9.4.3 **PROPOSED** HOTEL AND RESIDENTIAL RESORT **DEVELOPMENT – LOT 62 ROBERTS STREET, JURIEN BAY**

PROPOSAL

The Council in February 2010 received an application for a Hotel and Residential Resort to be constructed on Lot 62 Roberts Street, Jurien Bay.

Figure 6 - Replacement of Public Parking

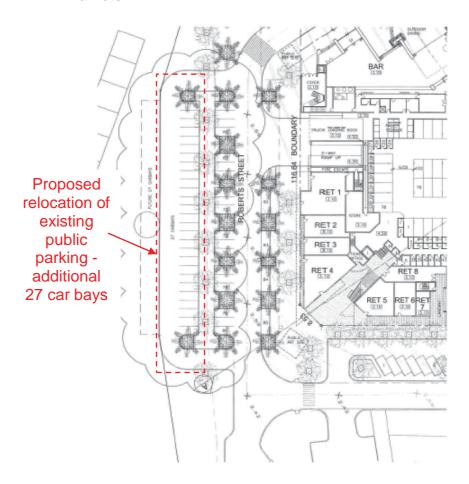
- 1. The proposed development requires a removal/loss of 53 existing car bays in Heaton and Roberts Street, with 27 of these bays proposed to be relocated to Roberts Street see Figure 6.
- 2. The application requests a concession for reciprocal use of 117 retail bays.
- 3. The application requests a concession by applying 1 bay for every residential unit (183 as opposed to 353 reduction of 170 bays)

With regard to the loss of public parking, being the existing 53 bays in Heaton and Roberts Street, the proponent should be required to replace this parking at construction cost only within 400 metres of the development site at the time and in a location as directed by the local government.

Figure 7 - Sight Lines

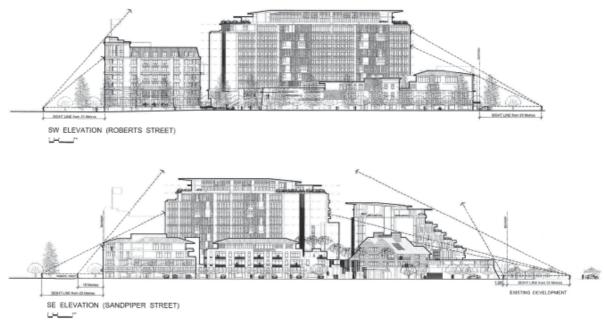
Site Suitability – The selected site being central to the town and adjacent to the coast ends itself to an iconic development adjacent to Dobbyn Park and the new Jurien Bay Community Jetty. However, relative to the existing built form the proposed development will prove to be significantly large, although it is acknowledged that strong consideration has been given to design, variation in scale and height of the individual buildings in order to avoid total domination of the skyline and minimize the impact from the street face. Nevertheless, the significance between the existing and proposed built form will be clearly obvious, as indicated in Figure 7.

Cause of Overshadowing - It is evident the proposed development has been designed to minimize overshadowing by applying a 'raked' effect to individual building heights as shown in Figure 7. However, given the scale of the development and location of the hotel component directly fronting Dobbyn Park there is likely to be a partial overshadowing effect on the jetty foreshore area for a number of hours in the morning as the sun rises. Similarly, a late afternoon shadow will be cast across Sandpiper Street that may have some effect on the adjacent commercial development and those units half way along the south west boundary of the Sea Front Villas development, as indicated in Figure 8, although it is not considered this will be significant as these units are also designed for short stay accommodation and are not permitted to be permanently occupied under the Management Statement.

Figure 8 - Option 2 Foreshore Plan - Heaton Street Road Reserve

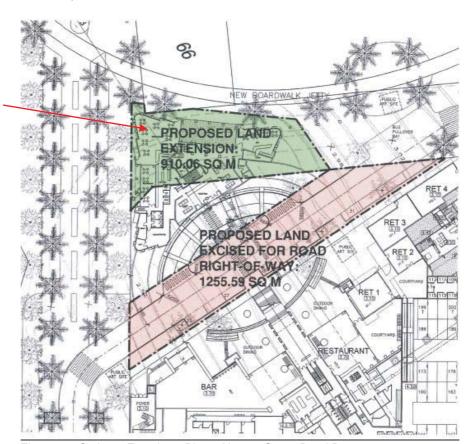
Furthermore, acceptance of the 'Option 2' Foreshore Plan and the grant of planning approval for the hotel component of the proposed development will require initiation of a formal road closure and rezoning process for the western portion of

Heaton Street, as shown in Figure 8. Notwithstanding this requirement, development approval may still be granted in the first instance, as outlined in the legal advice provided by the Shire's solicitor, although it would be appropriate for the Council to apply conditions that adequately address:

Portion of Heaton Street the subject of closure and rezoning proceedings

- The appropriate timing for commencement of formal processes including road closure and rezoning of the site – see further comment under <u>7. Staging</u> below;
- A detail understanding of the interface between the respective hotel development and foreshore enhancement works, including a contribution (financial or in-kind) toward the foreshore enhancement works and Roberts Street (jetty end).
